Road Safety Audit Stage 1 Response Report **A28 Sturry Link Road, Canterbury**

CO04300392/006 Revision 1

Project Name:	A28 Sturry Link Road, Canterbury
Project Number:	CO04300656
Report Title:	Road Safety Audit Stage 1 Response Report
Report Number:	CO04300392/006

Problem Location Plan (1 of 2) – with RSA report references

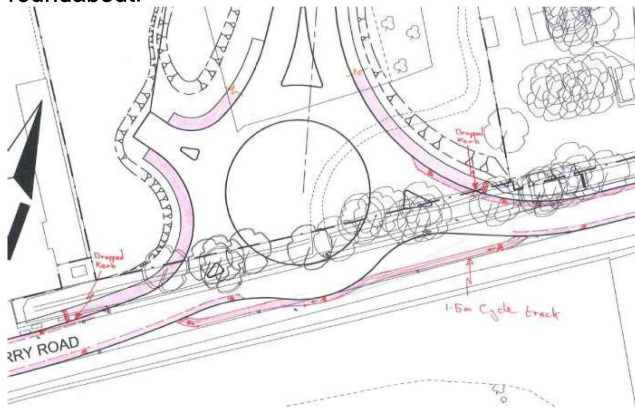
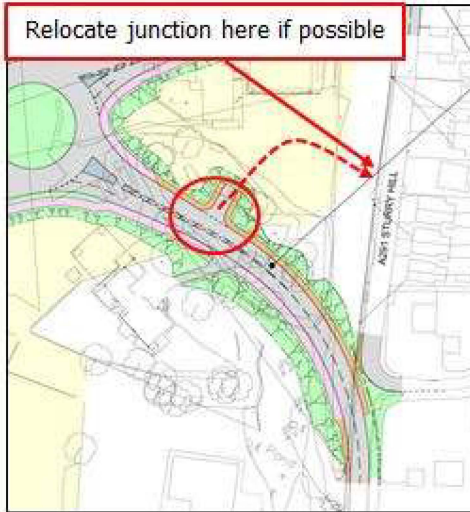
3.1.1	<p>PROBLEM</p> <p>Locations: New Junction with A28</p> <p>Summary: The A28 Sturry Road has dedicated cycle lanes on both westbound and eastbound at the location where the new roundabout is proposed.</p> <p>Under the proposed arrangement cyclists traveling on the westbound would need to enter the roundabout in order to continue ahead on A28 westbound. Cyclists are a vulnerable road user and they should be kept where possible out of the circulatory carriageway where they are potentially exposed to vehicle strikes.</p> <p>RECOMMENDATION</p> <p>Cyclists traveling on the A28 Sturry Road westbound should be provided with safe facilities to continue ahead and re-join the cycle lane.</p>	<p>Comment:-</p> <p>We accept the auditor's recommendation. A proposal to provide an off carriageway route for A28 westbound cyclists is shown below. This includes a 1.5m one-way cycle track skirting the southern side of the roundabout designed to minimise its impact on the existing southern verge and associated trees/vegetation.</p> <p>It should be noted that advisory cycle lanes are shown to commence immediately at the roundabout exit points. This will alert drivers to the potential presence of cyclists as they leave the roundabout, encouraging drivers to align themselves slightly away from the kerb, thereby making it safer for cyclists when entering the cycle lanes from the footways/cycle track. They also provide for a safer exit for those cyclists who choose to cycle on the roundabout.</p>  <p>Recommended Action:- As described above</p>	<p>The designer's recommendation is accepted</p> <p>Proposed Action:-</p> <p>To be incorporated into the design, may need to be developed to provide crossing points.</p>

3.1.2	<p>PROBLEM</p> <p>Locations: New Junction with A28</p> <p>Summary: Insufficient facilities for cyclist could result in vehicle / cyclist conflicts.</p> <p>From the drawings provided it appears that cyclists travelling either from A28 Sturry Road or from the New Link Road towards A28 Mill Road would need to re-join the carriageway in the proximity of the new roundabout exit. It is not clear at this stage how the existing cycle lane would be connected with the proposed shared footway. Motorists tend to accelerate when exiting the roundabout and could not expect cyclist to re-join the carriageway resulting in potential vehicle /cyclist conflicts.</p> <p>RECOMMENDATION:</p> <p>The shared footway should be extended to allow cyclists to join the carriageway further from the roundabout exit.</p> <p>The footway prior to the transition to the cycle lane should be segregated to avoid potential cyclist / pedestrian conflicts.</p>	<p>Comment:-</p> <p>The recommendation under 3.1.1 is considered to adequately address the concerns of potential vehicle/cyclist conflict at the exits as explained above.</p> <p>By extending the shared footway further downstream of the roundabout exit cyclists will be joining the carriageway at locations where traffic speeds would be higher than at the roundabout exit, placing cyclists at greater risk as a result. This is not therefore preferred.</p> <p>Where cyclists are invited to leave the carriageway on approach to the roundabout a short length of segregated footway as they exit is considered beneficial (i.e. on eastbound approach). This avoids the potential for cyclist to stop on carriageway should a pedestrian be present on the footway at the point of entry. These arrangements can however be complicated requiring much street furniture (i.e. tactile paving/signs). For that reason it is considered unnecessary to provide a similar arrangement where cyclists are entering the carriageway as the safety risk is considered much less and tolerable</p> <p>Recommended Action:-</p> <p>As 3.1.1 and in addition provide a short segregated section of footway onto which cyclists can enter when exiting the carriageway. The latter can be incorporated during the detail design stage.</p>	<p>The designer's recommendation is accepted</p> <p>Proposed Action:-</p> <p>To be incorporated into the design, may need to be developed to provide crossing points.</p>

3.1.3	<p>PROBLEM</p> <p>Location: Western footway termination.</p> <p>Summary: The audit team is aware that the drawings are only indicative at this stage however it appears that the new link road footway terminates on the most western point is leading to the carriageway. There is no footway on the opposite carriageway and visually impaired pedestrians could cross the road at a place where there is no corresponding footway at this location. Pedestrians may become 'stranded' in the carriageway where they would be vulnerable to vehicle strikes.</p> <p>RECOMMENDATION The footway arrangement should not lead into the carriageway at this location</p>	<p>Comment:- It is reasonable to expect that pedestrians with a visual impairment would already be aware of the road layout and facilities available to them prior to their journey. The occurrence of a visually impaired person being on their own crossing for the first time would be extremely unlikely. There is therefore considered to be no safety risk through unawareness of a footway on the north side.</p> <p>The design at this point is however subject to change as full details of the adjacent development proposals remain uncertain.</p> <p>Recommended Action: – None at this stage, but to be reviewed once full details of the adjacent development have been established.</p>	<p>The designer's recommendation is accepted</p> <p>Proposed Action:- To be reviewed as part of the detailed design including any provision for tactile paving.</p>

3.1.6	PROBLEM

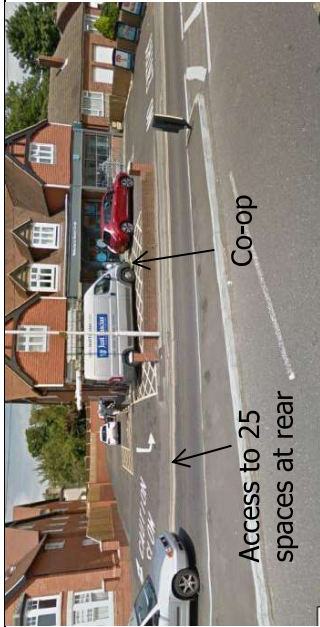
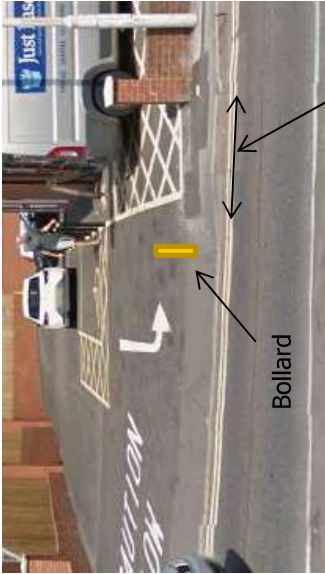
Item No.	Issues Identified and Their Recommendations	Design Project Manager's Response	Scheme Promoter's Decision And Proposed Action (as provided and approved by KCC)
	<p>Locations: A291 Sturry Hill Road</p> <p>Summary: Potential 'see through' on A291 Sturry Hill could lead to potential loss of control or nose to tail shunt collisions.</p> <p>The proposed works show that two new link roads from A291 are going to be constructed and the existing road between these new link roads is to be separated but retained.</p> <p>Under this arrangement there is the risk for motorists to misjudge the new road alignment and believe that the road continues ahead which can potential result in various types of collisions such as loss of control or nose to tail shunts.</p> <p>RECOMMENDATION Measures should be implemented to provide a clear separation between the new road alignment and the retained section of road such us:</p> <ul style="list-style-type: none"> • Vegetation on the side of the road to enhance the new alignment and to block the view towards the retained road. • Signing • Reflective marker posts 	<p>Comment:- Agreed. This can be addressed as part of the detailed design</p> <p>Recommended Action:- None at this stage but measures to provide a clear separation or screening between new and existing alignments should be identified and incorporated in the scheme during the detailed design stage.</p>	<p>The designer's recommendation is accepted</p> <p>Proposed Action:- To be incorporated into the detailed design.</p>
